Re: Fire Station #5 Plan Review Conditions from 12/07/2022

Building Plan Review Reviewed By: Joe Frogge Rejected

Reference: Lee's Summit Fire Station 4 Storm Shelter Peer Review

UL DETAILS

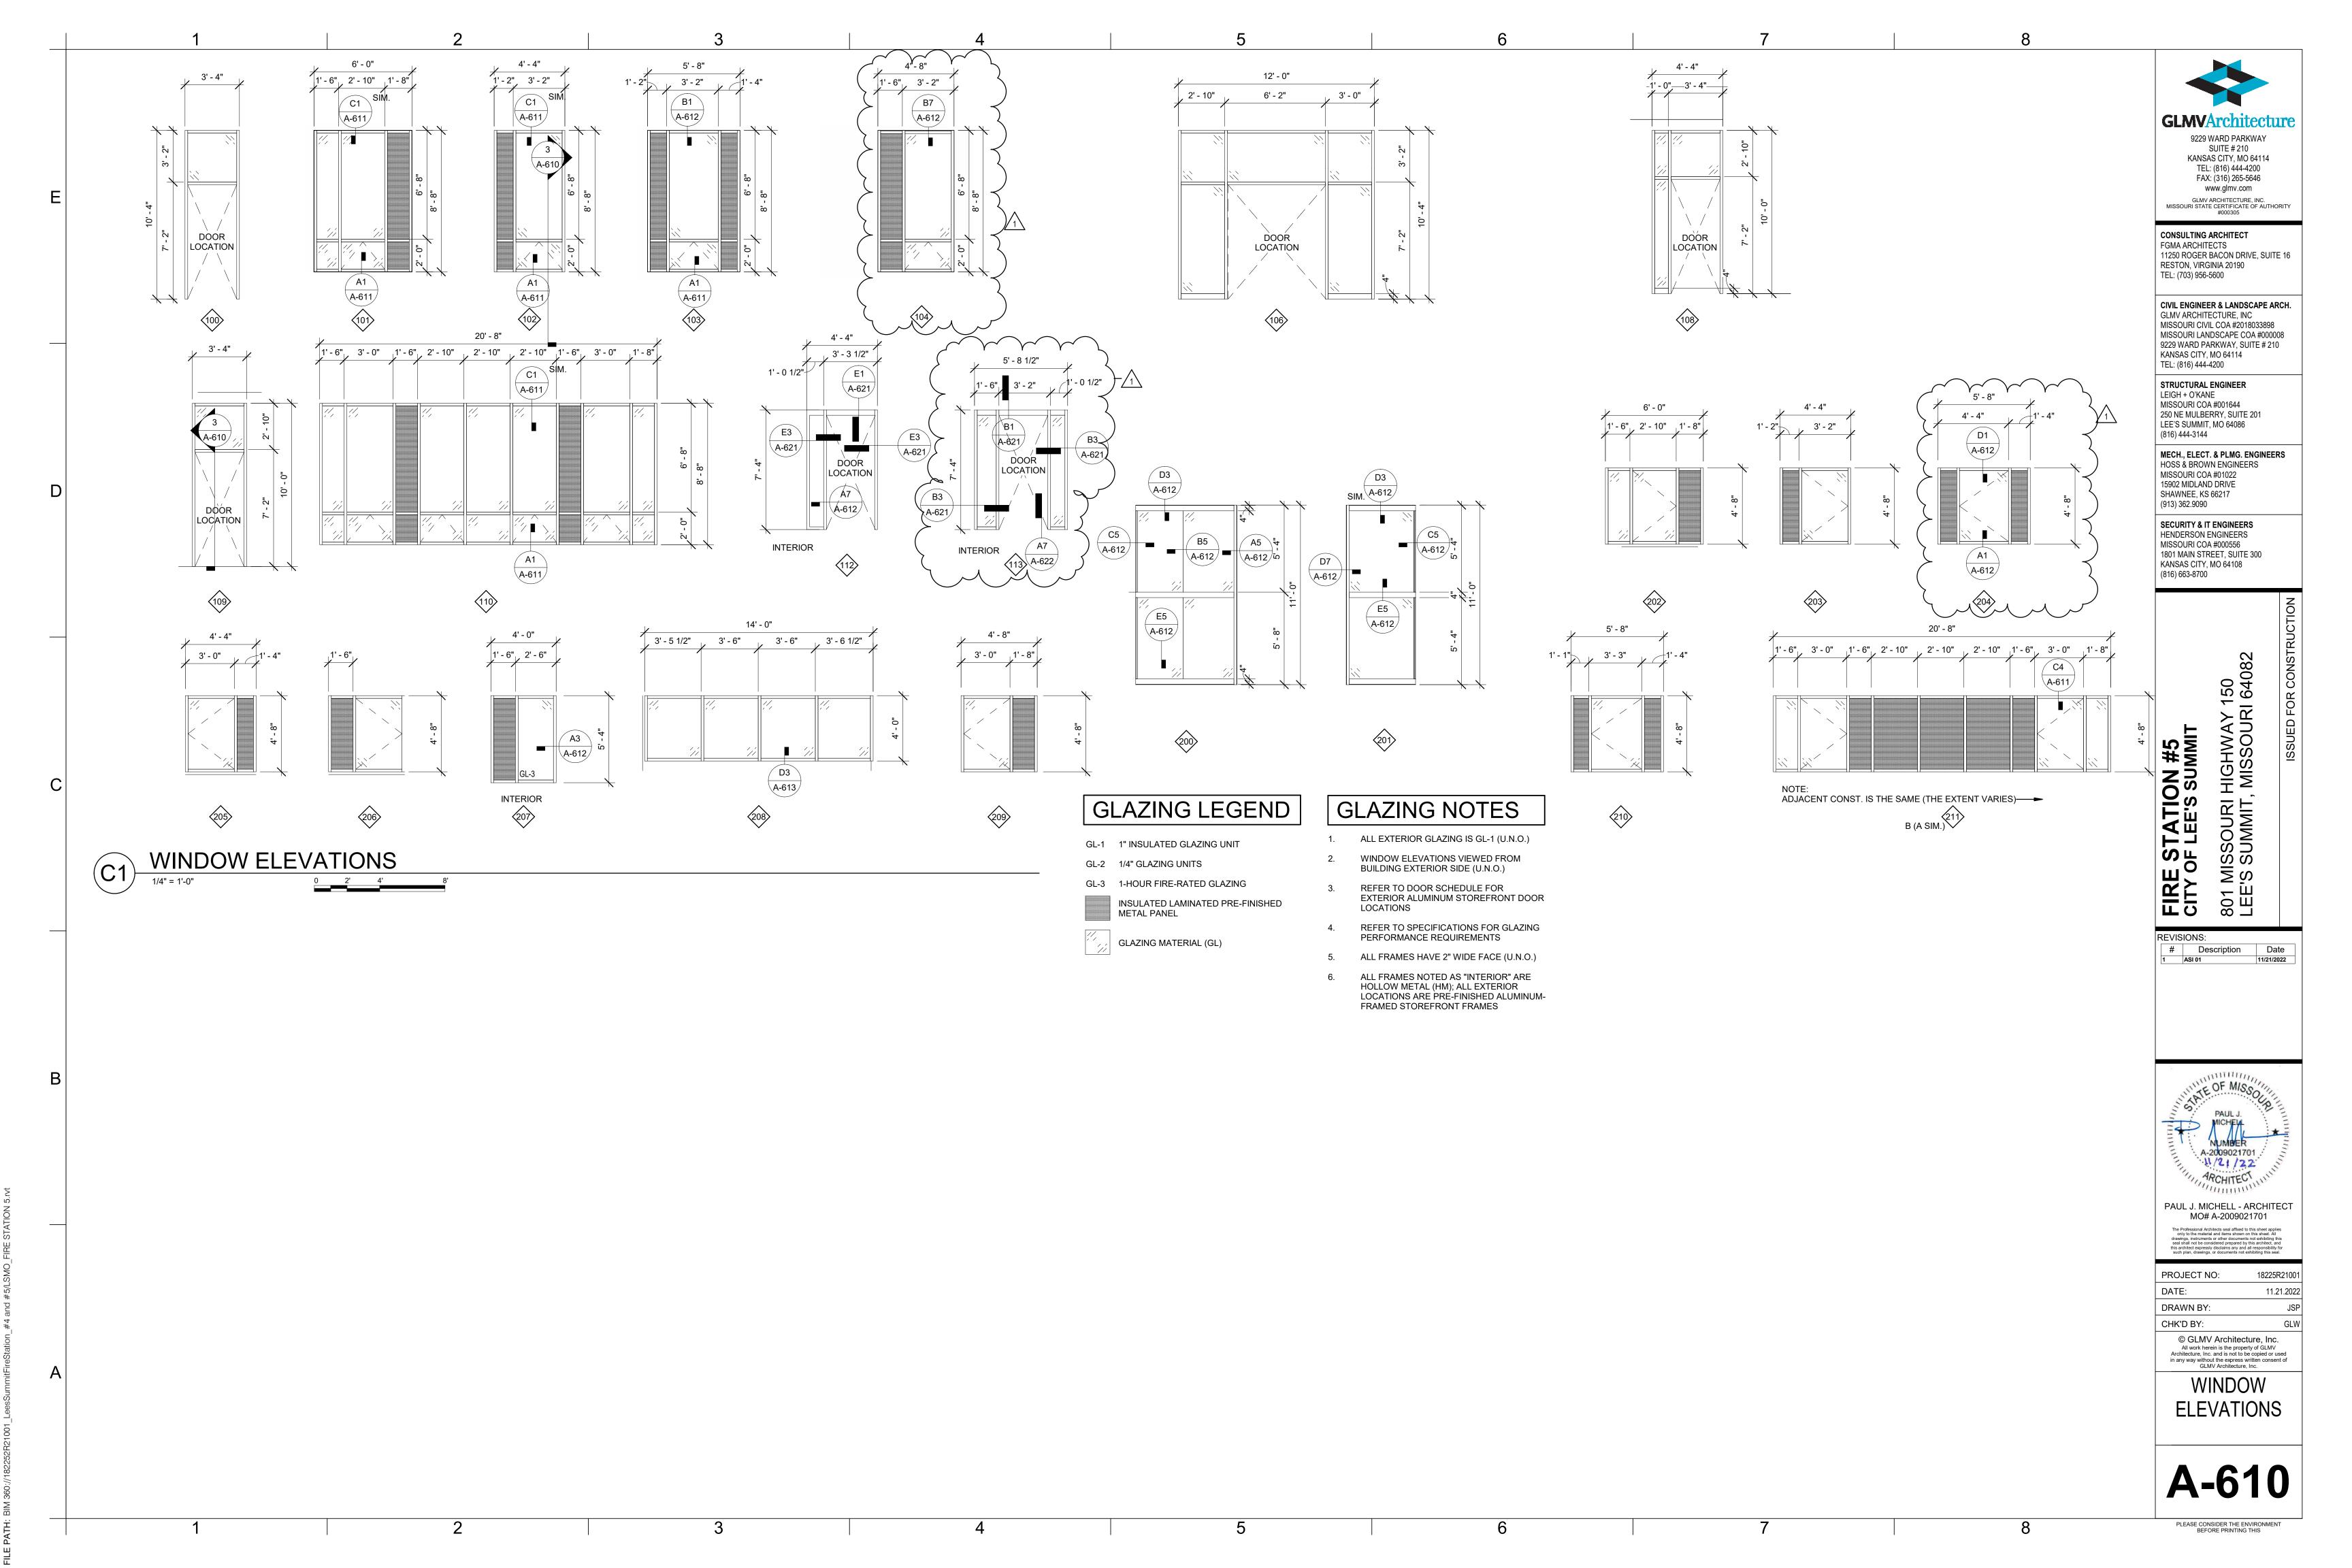
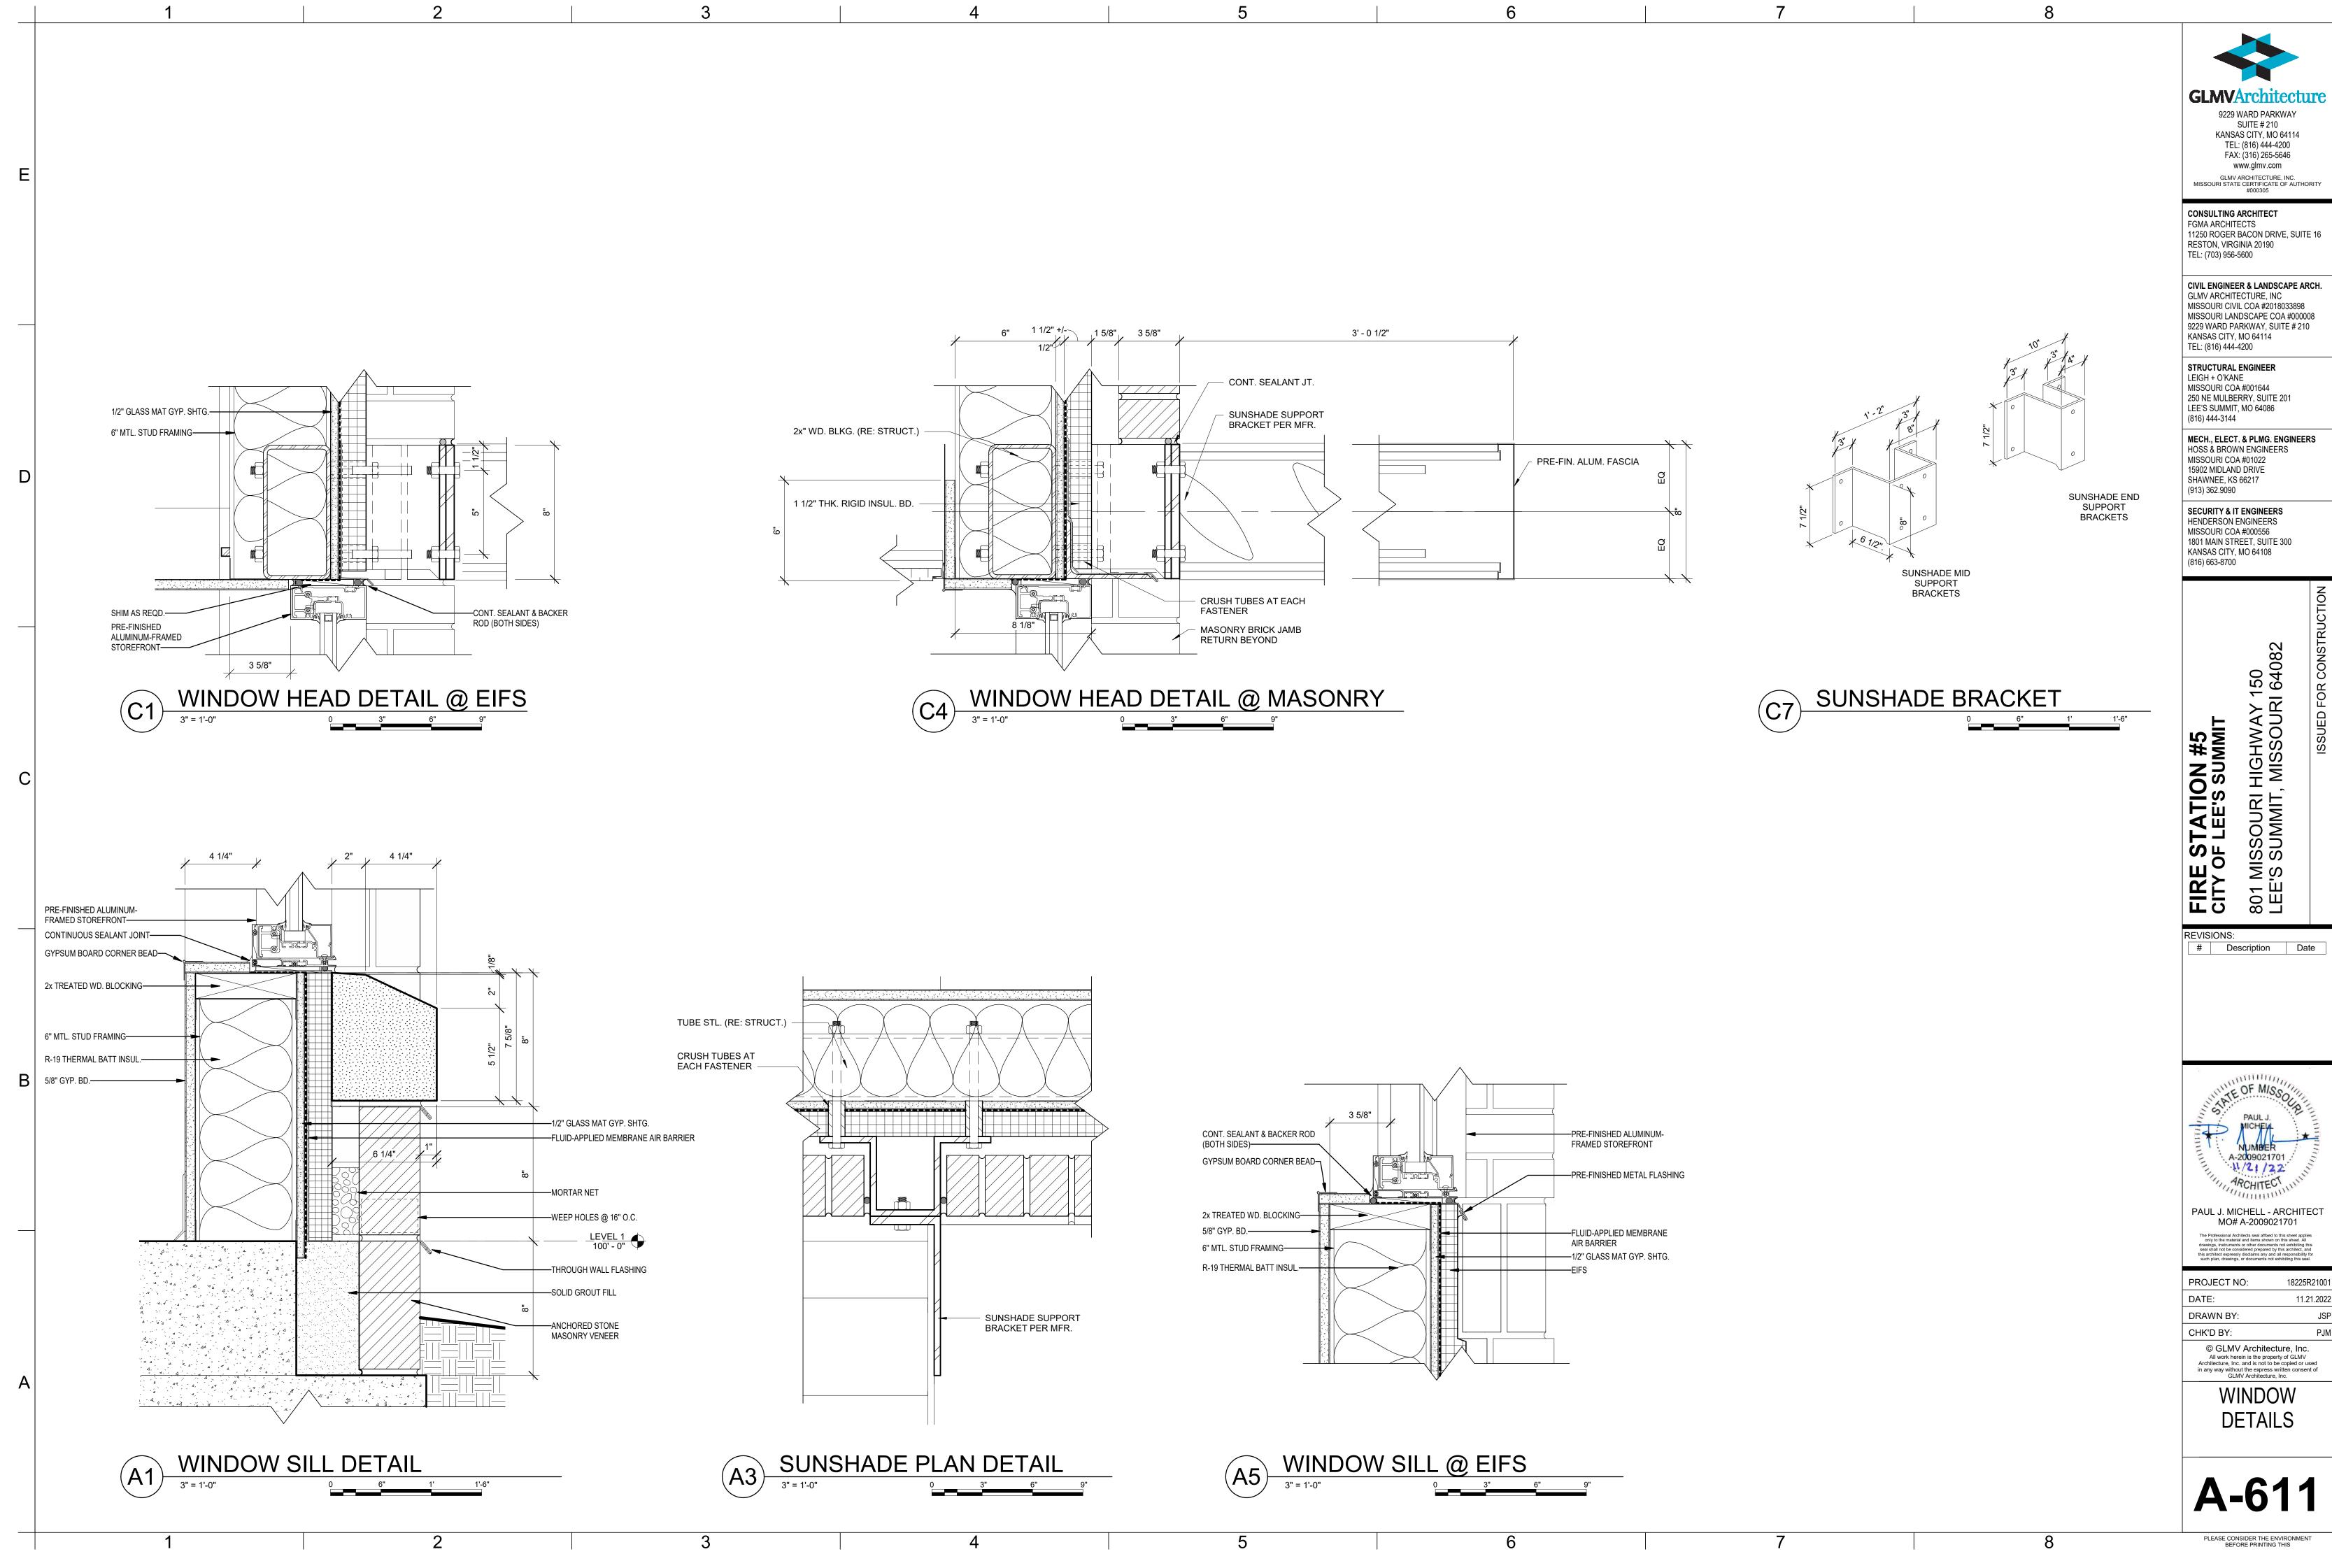
7. 2018 IBC 706.1 General. Fire walls shall be constructed in accordance with Section 706.2 through 706.11. The extent and location of such fire walls shall provide a complete separation. Where a fire wall also separates occupancies that are required to be separated by a fire barrier wall, the most restrictive requirements of each separation shall apply.

Action required: Provide complete UL details that include nail/screw patterns. 12/5/22 - Complete detail for UL 419 required

Responses: 12/23/2022 UL details, including fastener patterns for track, framing and sheathing are shown on sheet A-602 (see attached drawing sheet)
